A7. POST-APPLICATION DISCUSSION

COMMENTS BY THE PRIMROSE HILL CONSERVATION AREA ADVISORY COMMITTEE

Primrose Hill Primary School Princess Road NW1 8JL Listed Building PRE-APP

LB PLANNING AND CONSERVATION

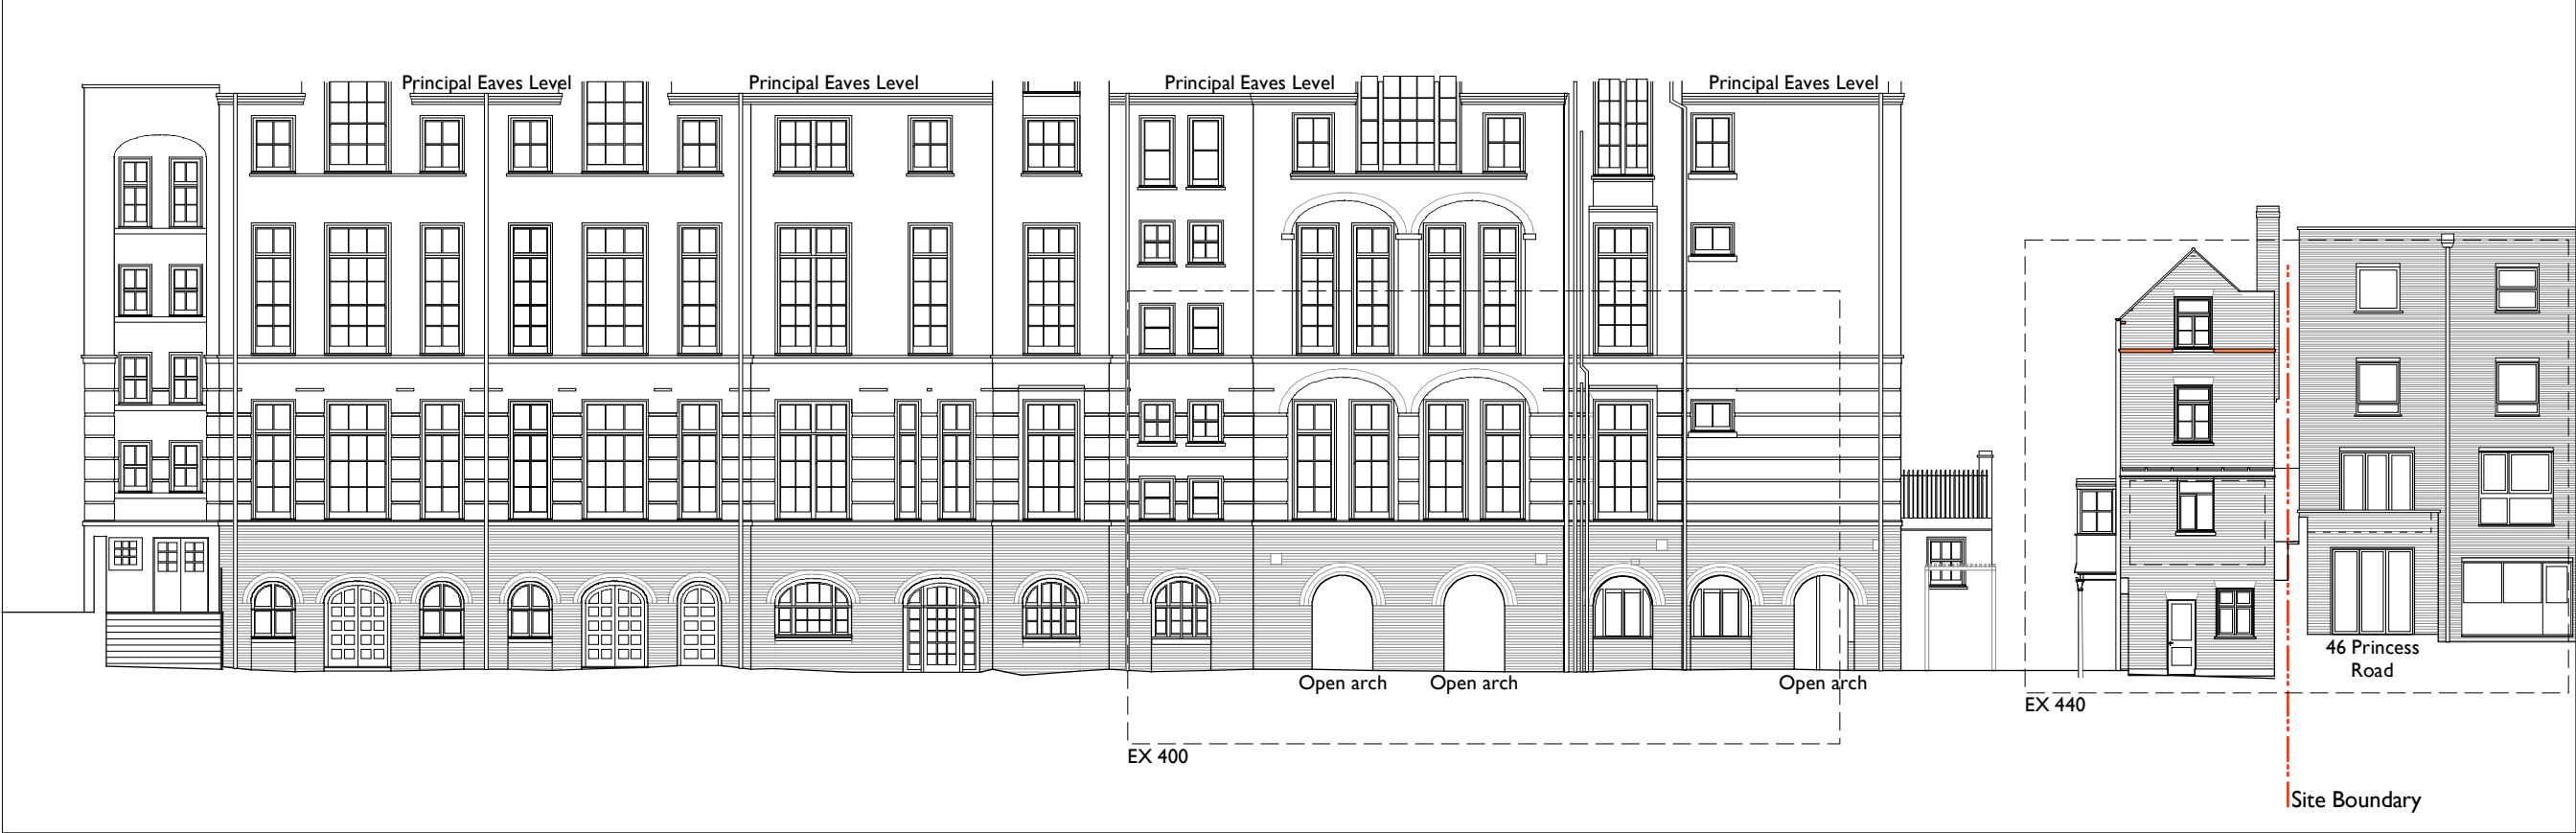
3. Sedum to be considered on roof of Buffer Zone.

4. Glazing to the Canopy would be welcome.

Response: A sedum roof covering is incorporated on the Buffer Zone. Drawing attached below: PRPS PR 112_G.

Response: Glazing to the canopy has been incorporated. Drawings attached below: PRPS PR 112_G, PHPS 200_G and PRPS PR 541_G.

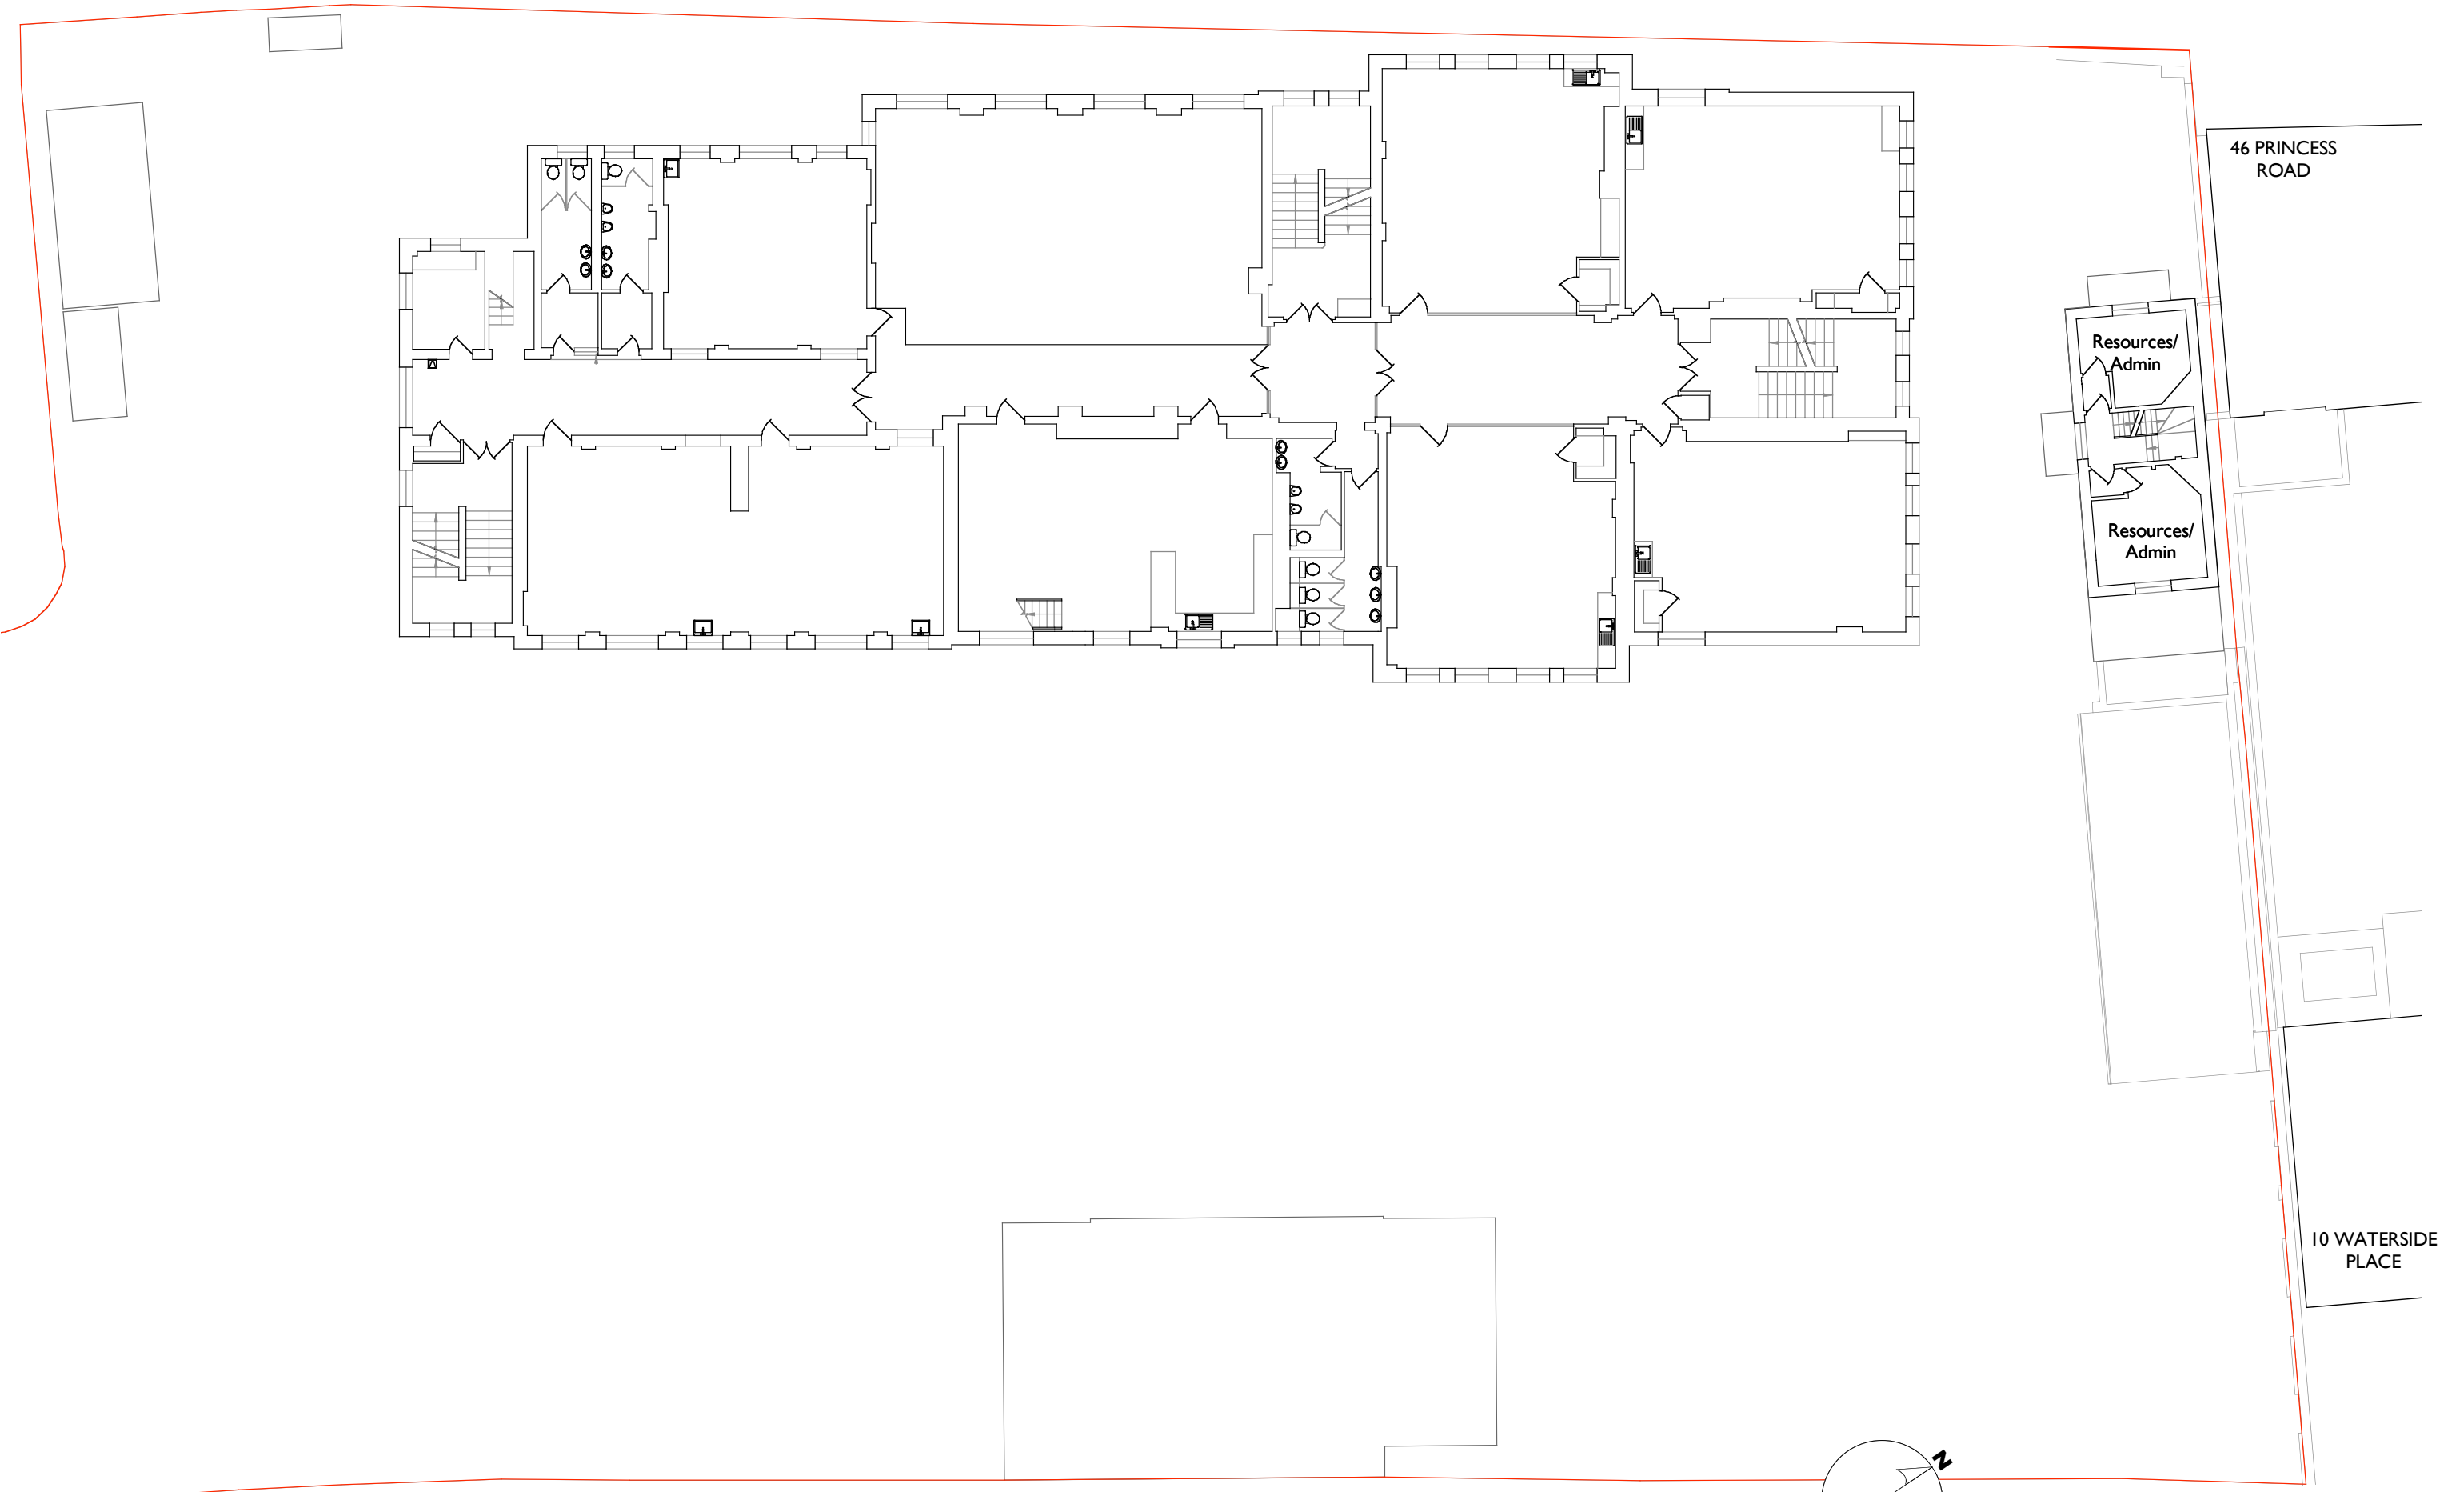
- 6. The canopy should clear the brick arches of the main building.

Job	Drawing No	Rev
PHPS	EX120	G

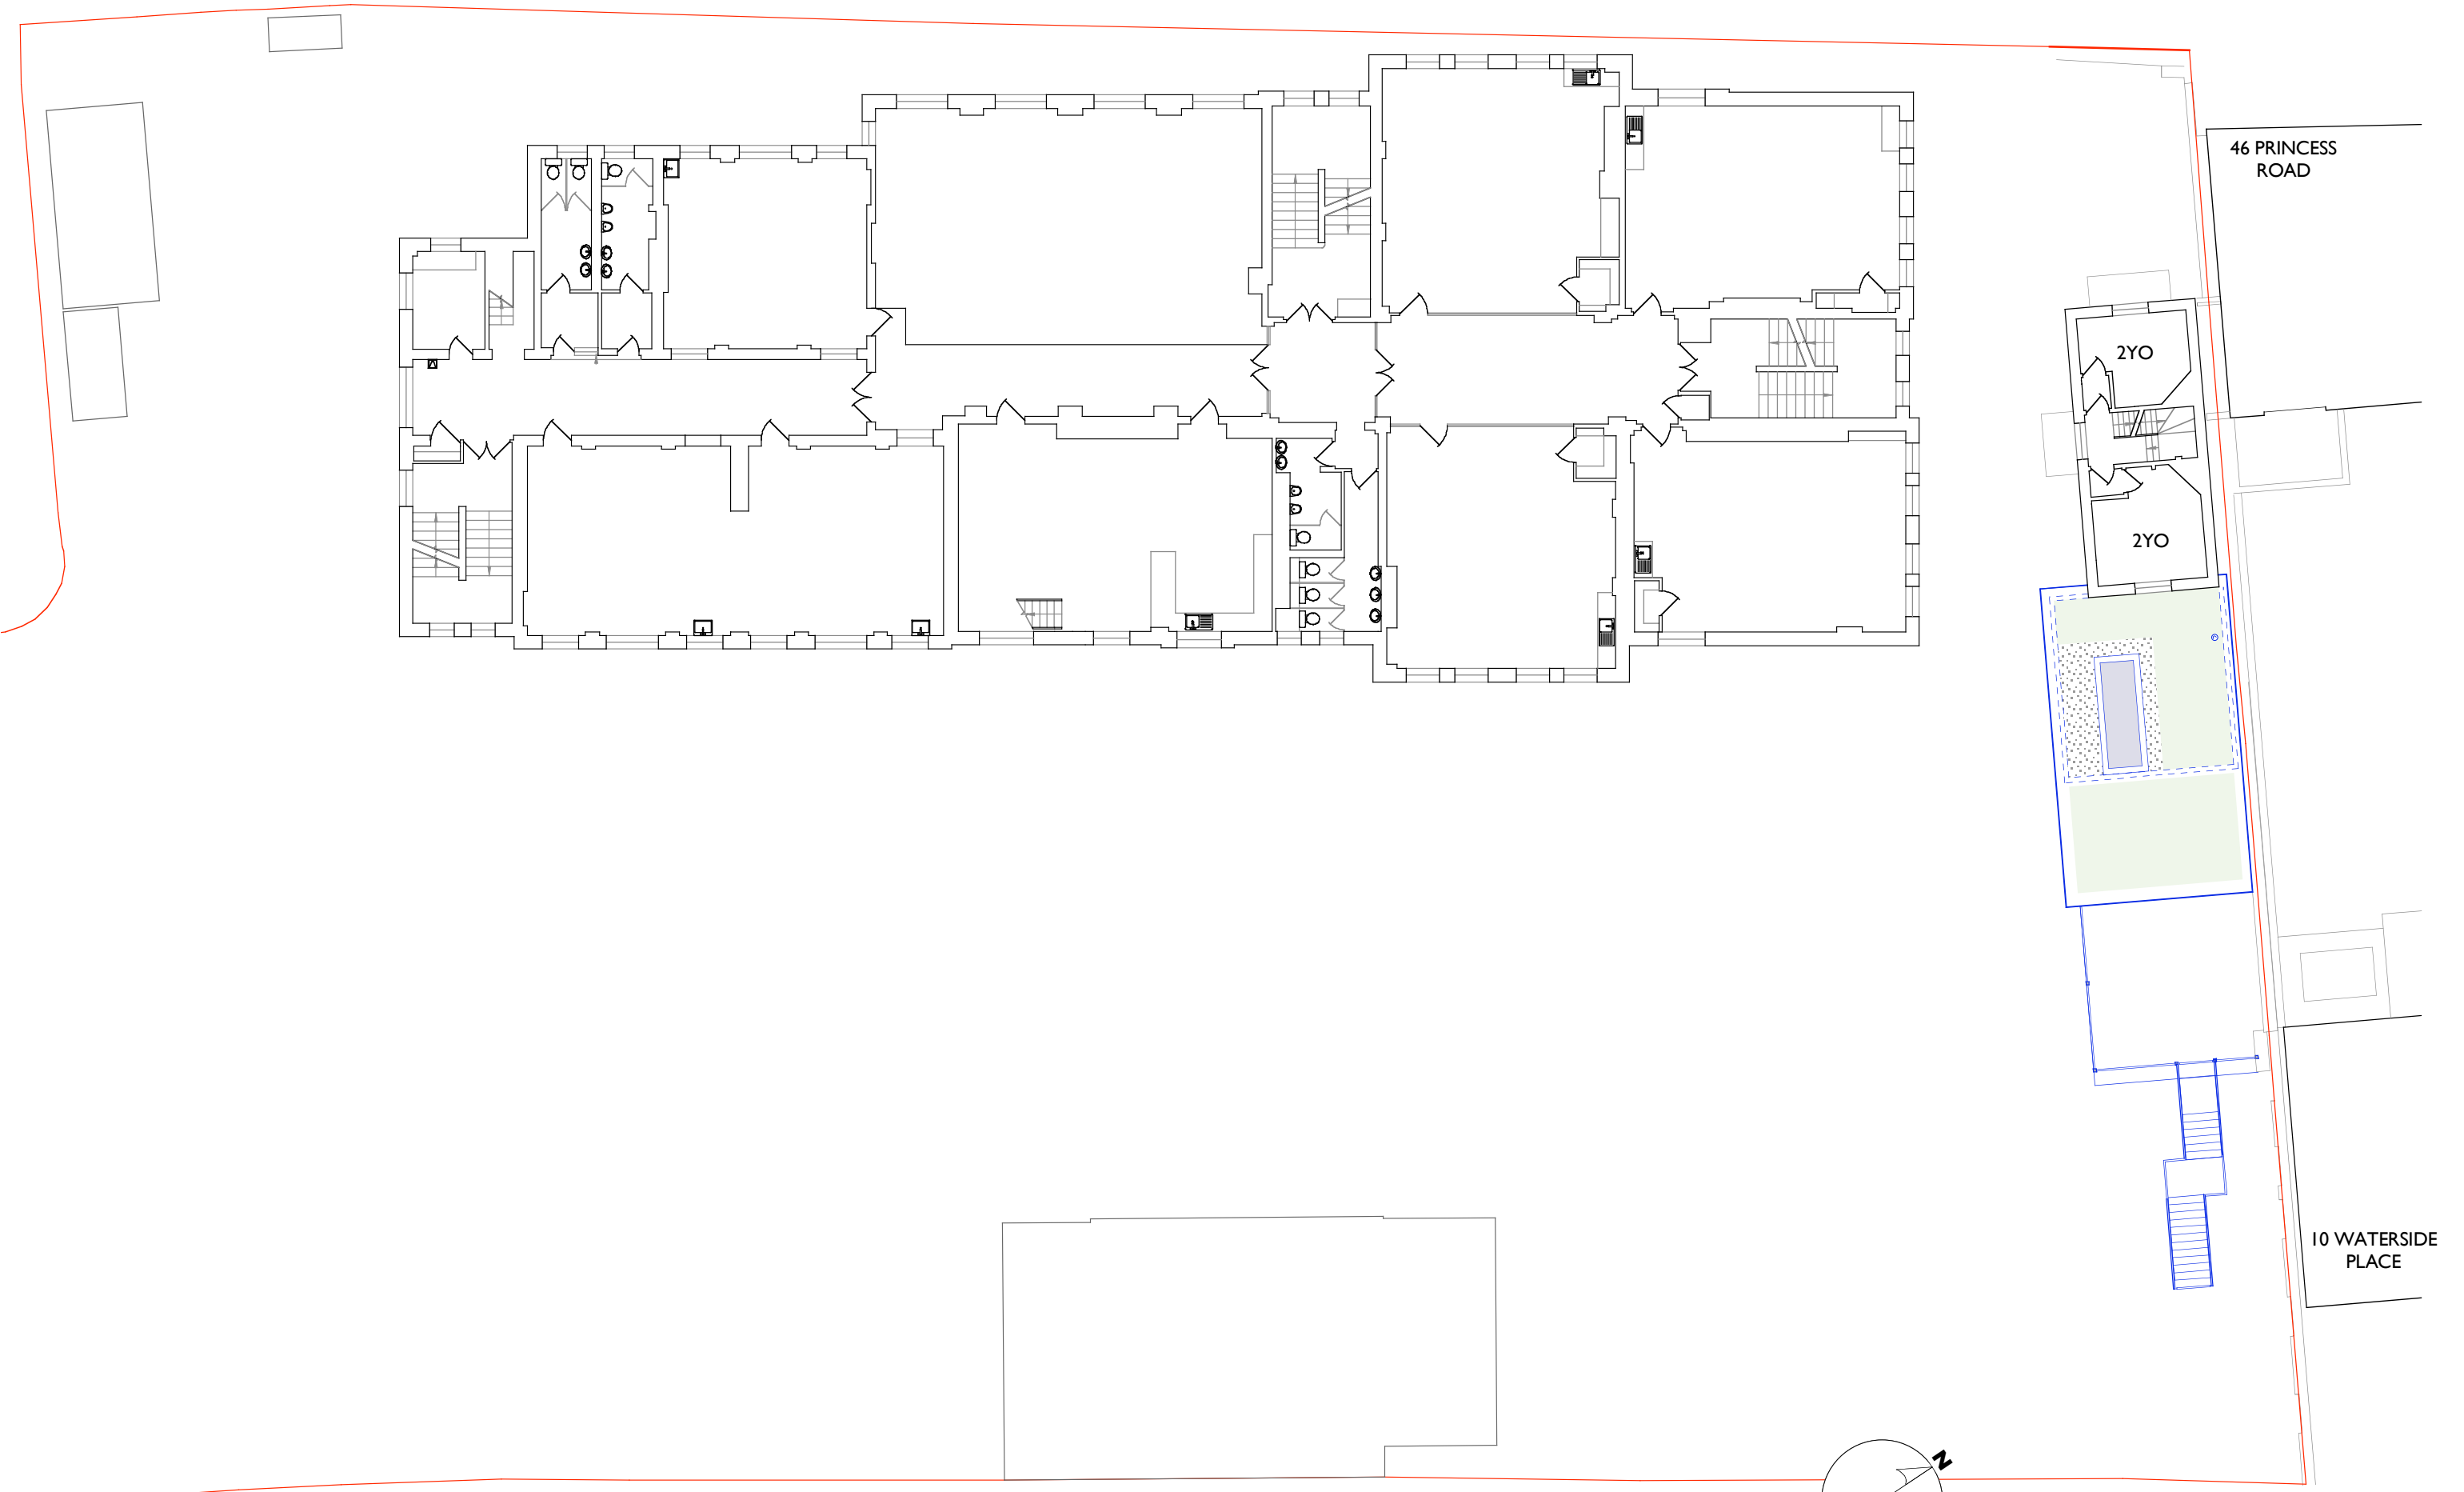
22. Confirmation of proposed numbers of two year-old provision.

Response: There are two phases for the introduction of two year-old provision at Primrose Hill School. In January 2017 the first phase will take twelve children and will use the street level floor of the Caretaker’s House. Depending on take up and interest the second floor may commence the following academic year, taking a further eight children on the first floor level. The top (second) floor of the Caretaker’s House will remain as a resource for the School staff and professionals who work with the children at the school..
There are no proposed changes to the layout or fabric of the first floor. Existing and proposed upper floor plans of the Caretaker’s House are attached below: PRPS EX 120_G, PRPS PR 122_G and PRPS EX 130_G.
